02I003

SUBJECT: Optional Upgrade Program 02B02-S1: Certain 1998 through 2003 Model Year Crown Victoria Police Interceptor (CVPI) Vehicles Currently in Law Enforcement Duty - Inspection of Optional Police Interceptor Package Upgrade Kit Installation

REF: Optional Upgrade Program 02B02: TECHNICAL INSTRUCTIONS REINFORCEMENT (dated March 2003)

FIGURE 1

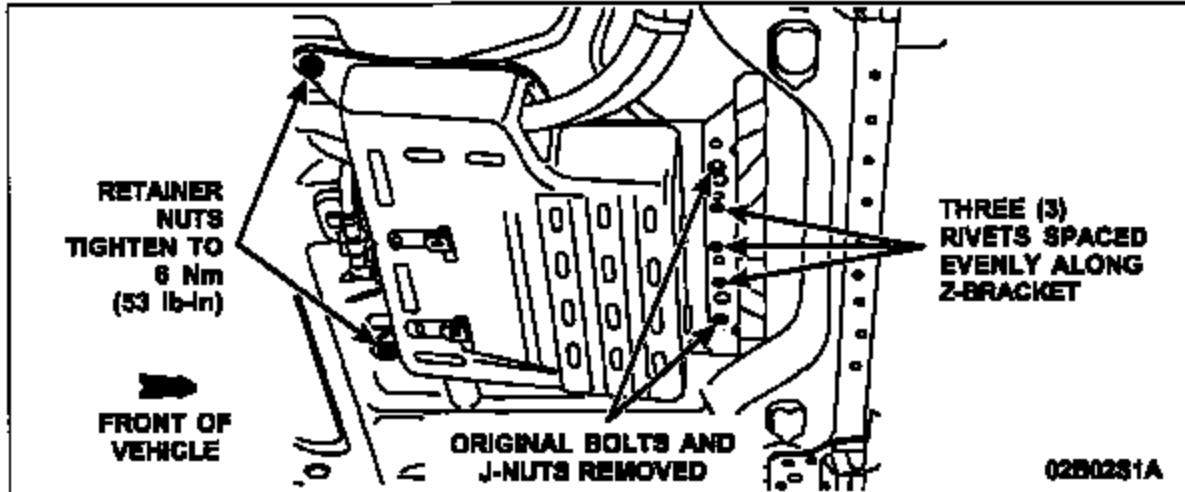
See Figure 1.

- Verify the original attaching hardware (bolts and J-clips) has been removed and discarded from the front edge of the canister along the Z-bracket.
- Verify the three (3) rivets have been installed equal distances apart from each other (about 2 inches) on the front edge of the of the canister along the Z-bracket.
- Verify the canister retainer nuts, located at the rear corners of the canister assembly, are tightened to specification (6 Nm [53 lb-in]).

If the bolts and/or J-nuts are still installed, they must be removed. If the rivets are installed, they will need to be drilled out to allow removal of the J-nuts. Once they are removed, *NEW* high clamp-load rivets must be installed as outlined in 02B02 Attachment III.
